ST. CHARLES SINCE 1834	**PLAN COMMISSION AGENDA ITEM EXECUTIVE SUMMARY**			
	Project Title/Address:	McGrath Business Center		
	City Staff:	Russell Colby, Assistant Director of Community & Economic Development		
	PUBLIC HEARING 2/2/21	X	**MEETING 2/2/21**	X
APPLICATIONS:		Special Use for PUD, PUD Preliminary Plan		
ATTACHMENTS AND SUPPORTING DOCUMENTS:				
Staff Report		Applications & Plans

Staff Report

RE: McGrath Business Center

DATE: January 29, 2021

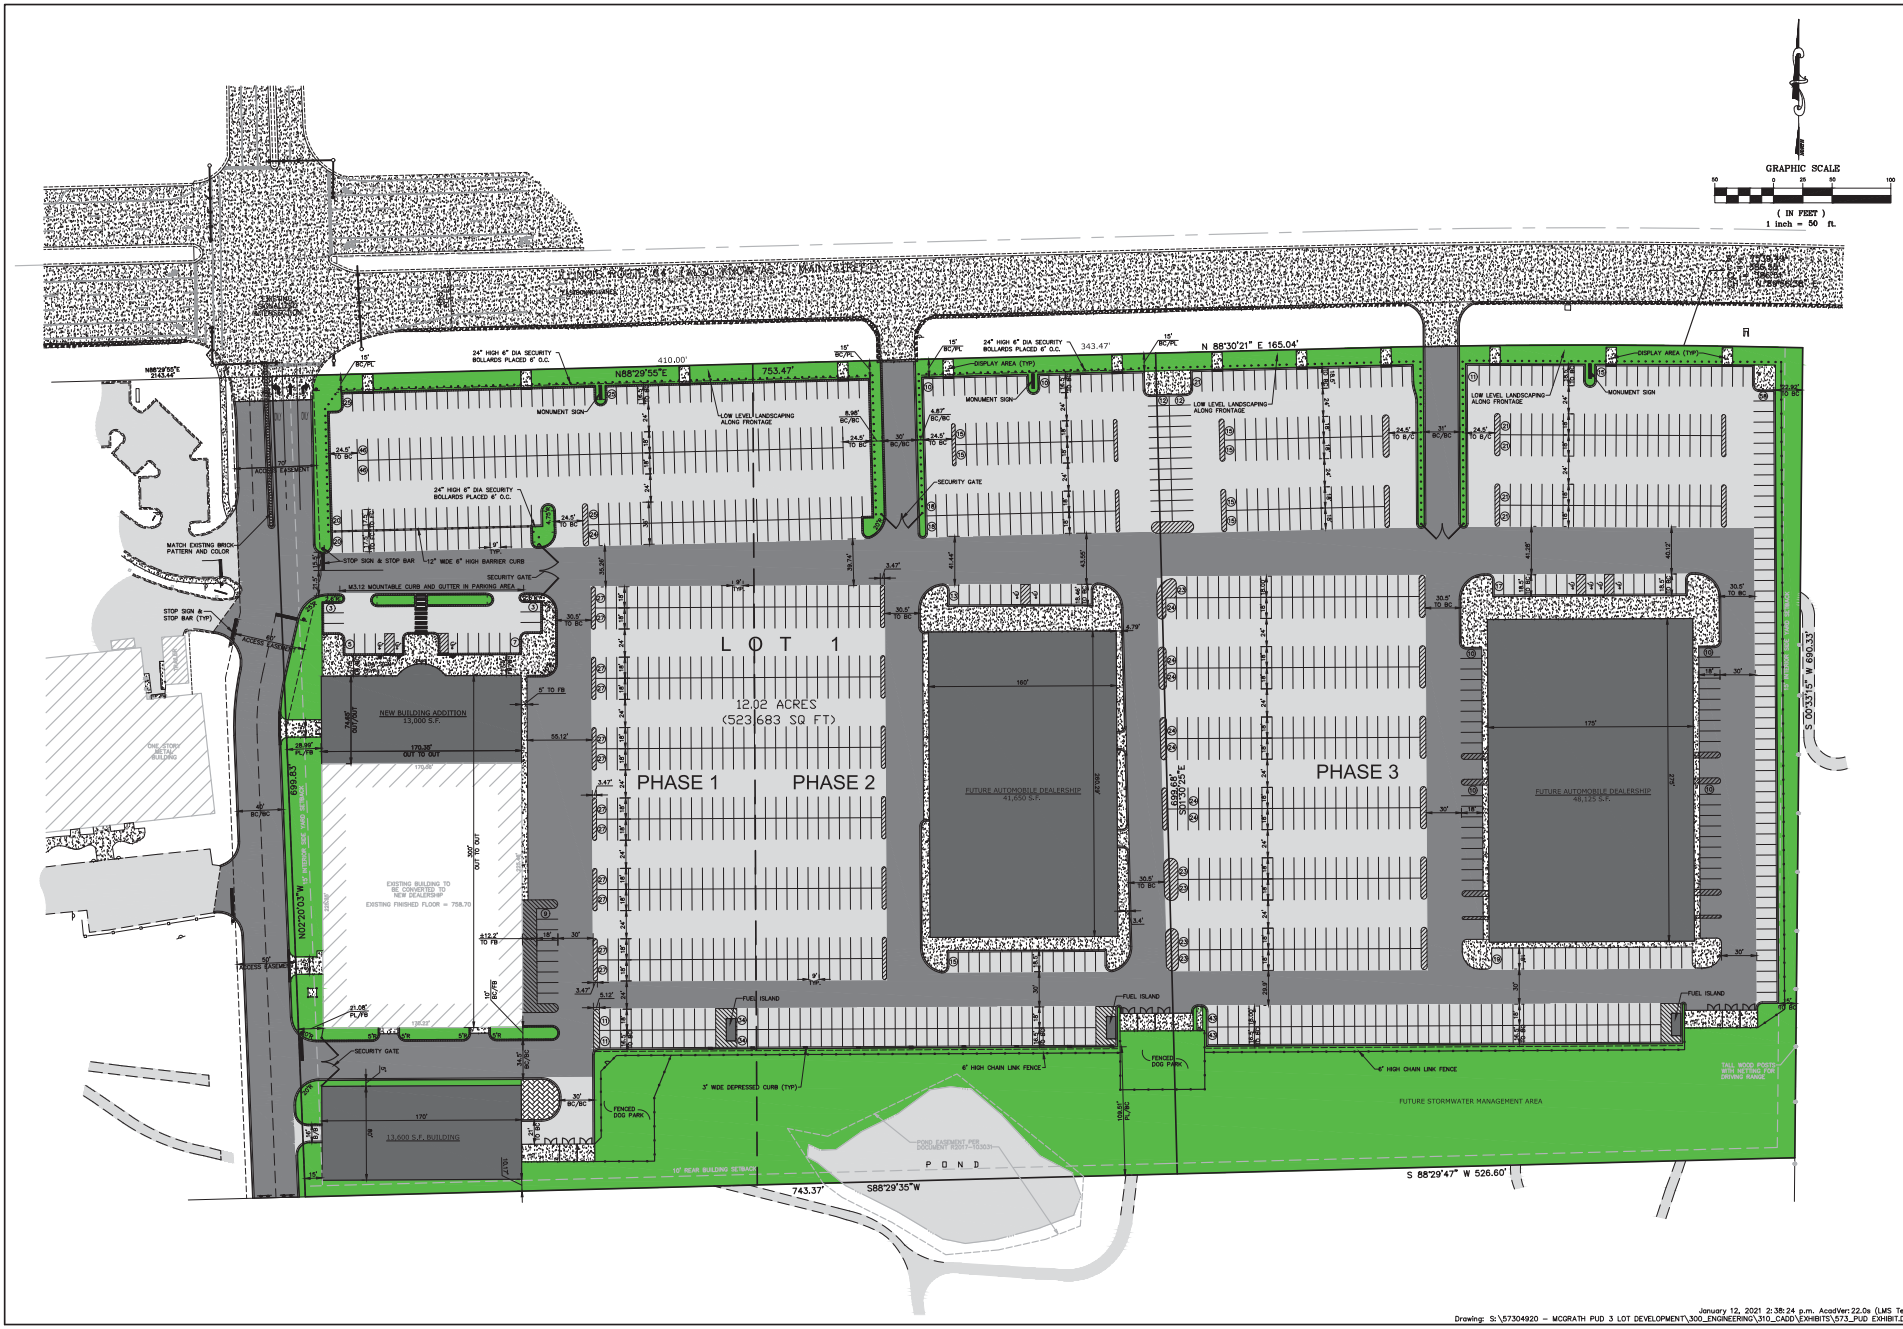
- During the Concept Plan review, there was discussion of a future gateway feature at the northeast corner of Phase 3. This should depicted on the PUD Exhibit. The City has been interested in establishing signage and potentially other gateway elements in the general area as the main entrance into St. Charles from the east. The PUD would provide flexibility to consider a unique design with community signage.

NORTH ELEVATION 1
SCALE: 1/8"

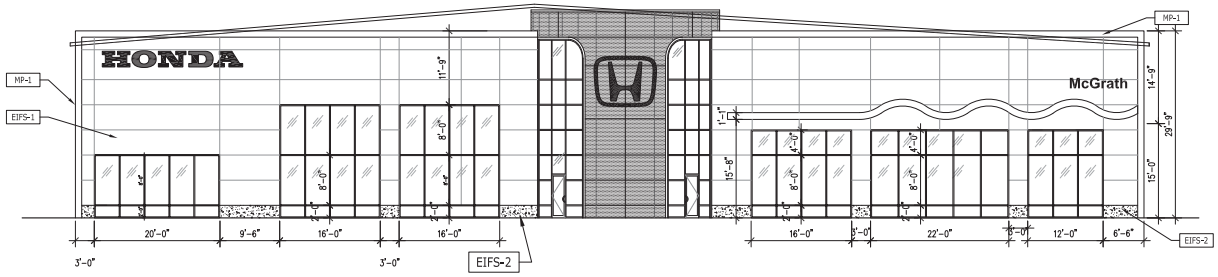
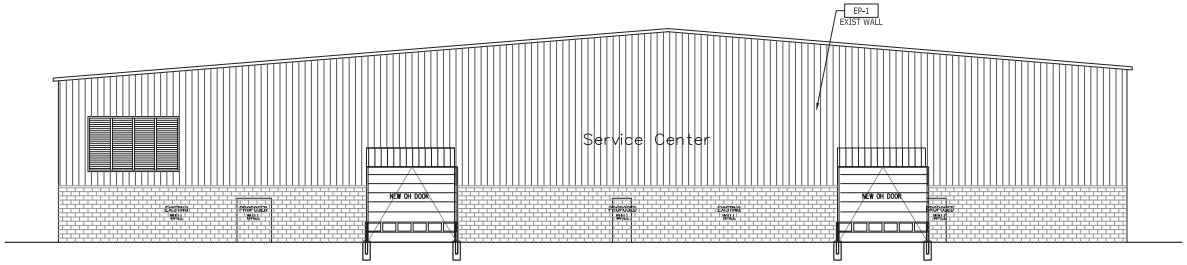
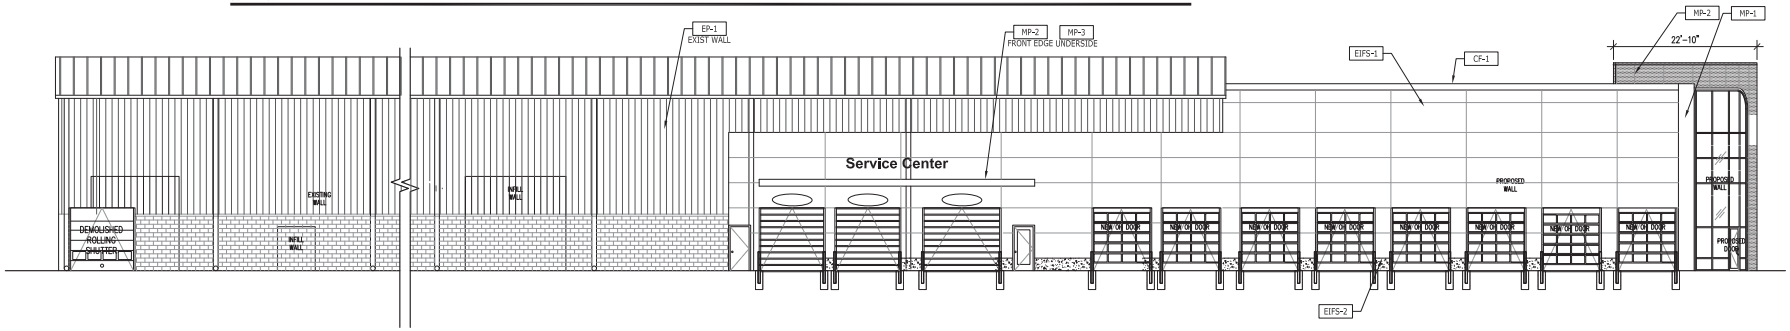
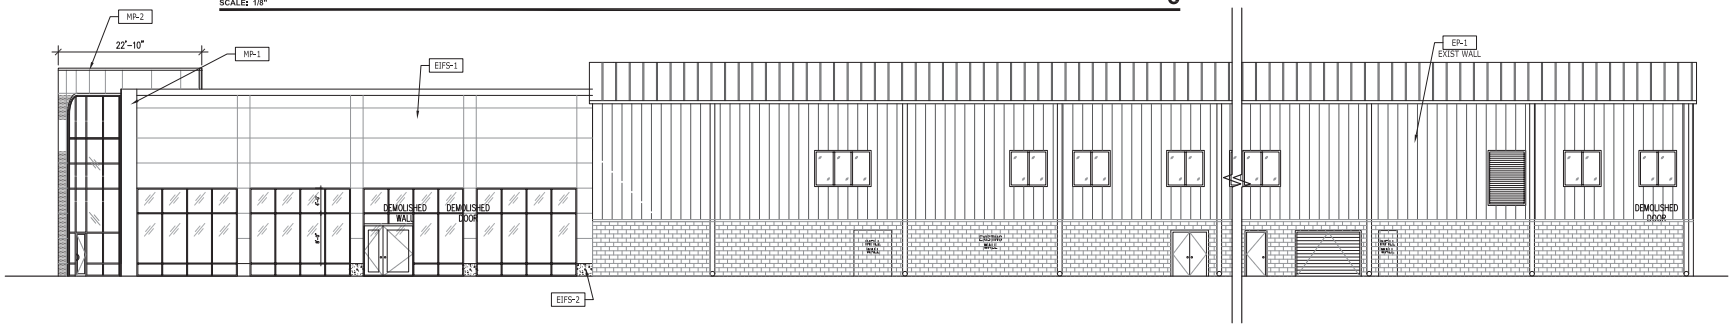
- The existing former Mega Center building is primarily vertical metal panel siding, which is not a permitted material for new buildings.
- Large portions of the building addition and a section of the existing building are proposed to be sided with EIFS material (exterior insulated finishing system). The Design Standards limit the location and extent of EIFS material. A PUD deviation is required for the plans as proposed. This deviation could be eliminated or reduced by replacing EIFS with metal composite panels. Alternately, a masonry material could be used at the lower sections of walls where EIFS material could be more easily damaged.

# of Architectural Features	Street-facing facades must have 2 of 4 architectural features: change in wall plane of 2 ft.; change in wall texture/masonry patterns; transparent windows; columns/pilasters projecting 6 in.	Meets standard
Public Entrance	Public entrance must face primary street frontage	Meets standard
Entrance Articulation	Public entrances must be articulated from building	Meets standard
Building Materials	• Brick, Architectural Metal, Metal Composite Panels permitted • Pre-fabricated steel panels not permitted • EIFS may not be used in the lower 10 ft. of the wall and not cover more than 10% of any building wall	• Brick, Architectural Metal, Metal Composite Panels • ***Vertical steel panels are an existing material*** • ***EIFS does not meet standard, used on lower 10 ft. of wall and over 10% of front and side elevations***

1 LANDSCAPE PLAN
SCALE: 1" = 40'-0"

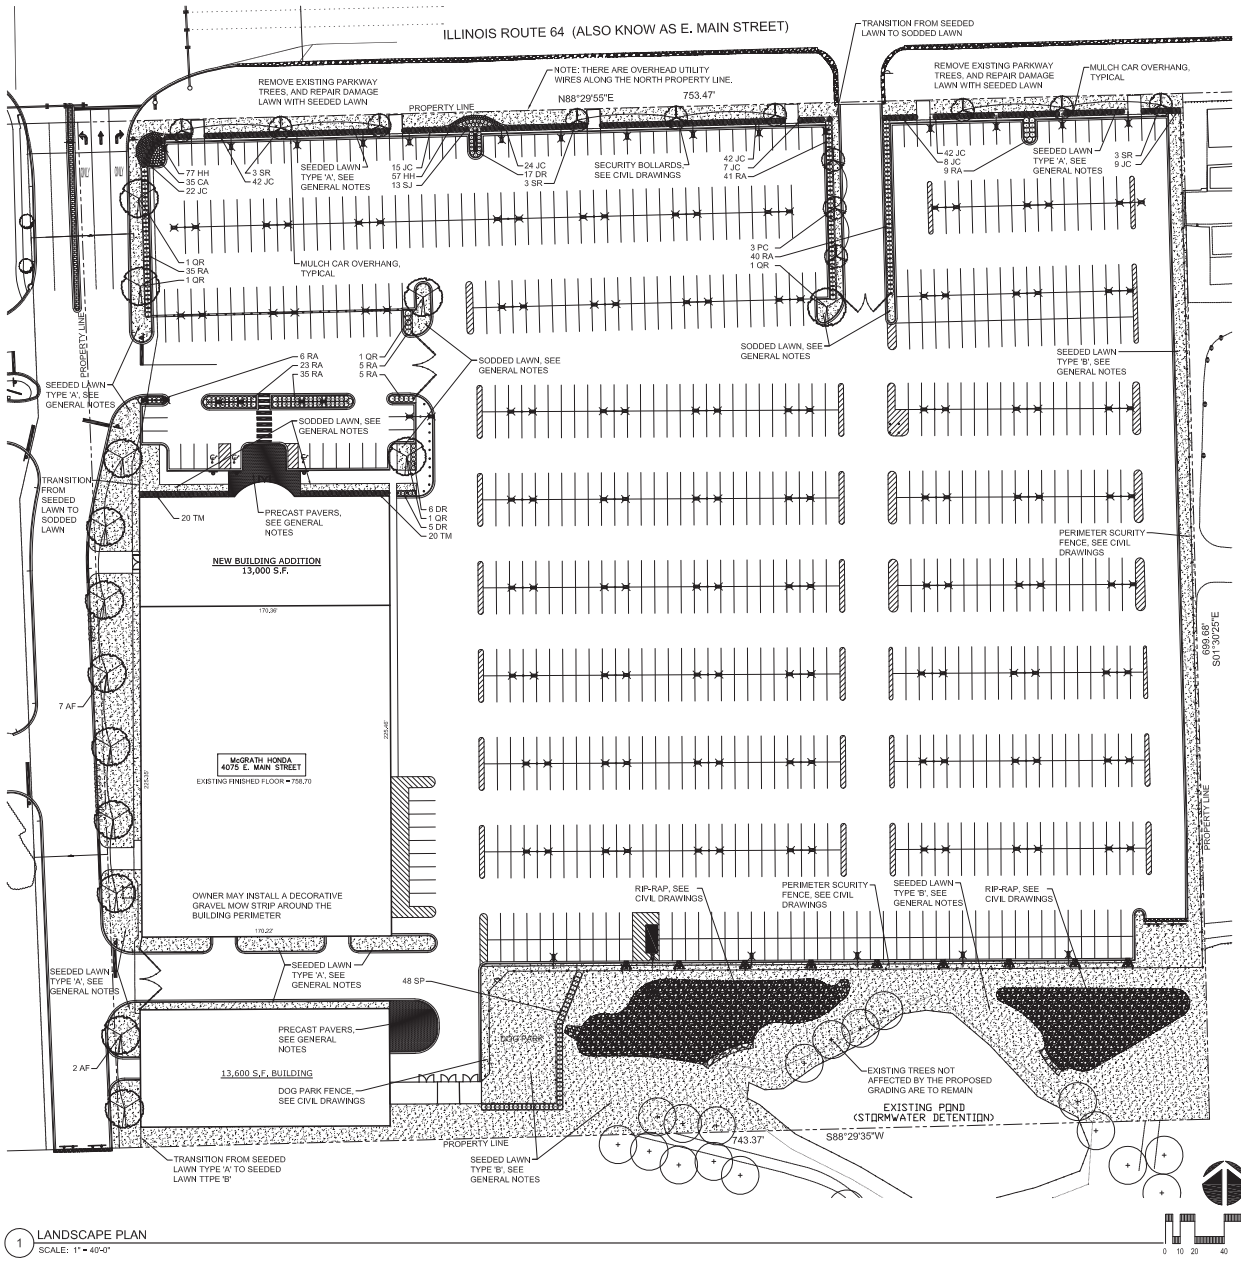
- As discussed during the Concept Plan review, a number of landscape deviations are requested to accommodate requirements specific to a large auto dealership facility, including street frontage/screening and internal parking lot landscaping.

- Along the Main Street frontage, additional plantings could be added to supplement the proposed evergreen shrubs. Alternately, different shrub species or perennials could be utilized for more variety and visual interest.

Building Foundation Landscaping (Motor Vehicle Sales and Leasing Establishments)	• Planting beds along 50% combined length of all walls excluding doors. • Planting beds along not less than 50% of front/street facing wall. • Plant requirement: Based on combined length of all walls, 2 trees and 20 shrubs per 50 ft. Where a Motor Vehicle Display area adjoins a building wall containing showroom display windows, Building Foundation Landscaping may be relocated when: 1. An equivalent amount of Building Foundation Landscaping is provided at an alternate location between the building wall and the street, at a location not more than 125 feet from the building wall. 2. The vehicle display area adjacent to the building wall is constructed as a concrete-curbed platform, paved with decorative concrete or masonry. 3. Building Foundation Landscaping is provided adjacent to or within 16 ft. of all exterior corners of the building wall.	• ***No plantings along side or rear walls.*** • Plantings are provided along the showroom display windows on the north elevation (70% of the elevation) • The entry walkway is shown as Precast Pavers. • Landscaping is provided at both the northeast and northwest corners. Additional landscaping could be added in the sodded lawn areas at the building corners.

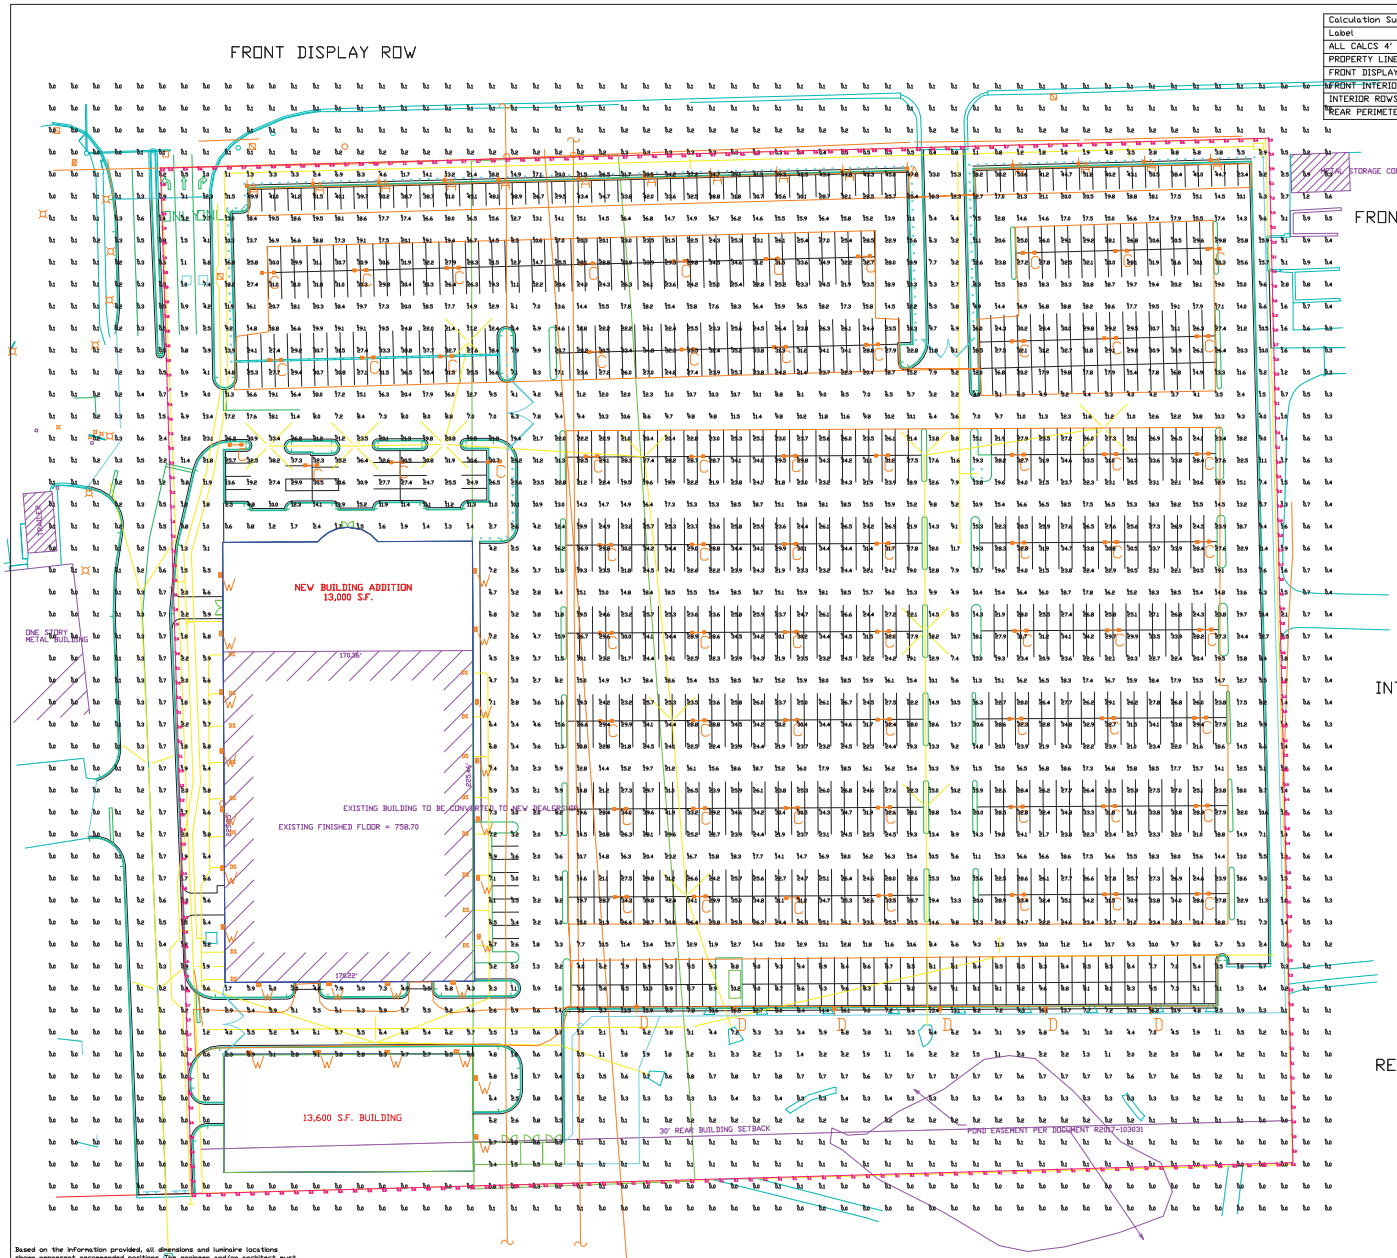
A photometric plan has been submitted showing building and parking lot lighting. Poles are 26 ft. in height.

The photometric plan shows average footcandles that fall within the maximum limitations. The east lot line may exceed the 2.0 average, however this is expected to be a common lot line with an additional dealership, and can be noted as a PUD Deviation.

During the Concept Plan review, there was a comment regarding use of cut-off lighting fixtures to block the view of the light source from Main Street. The fixtures proposed do not show a cut-off element.
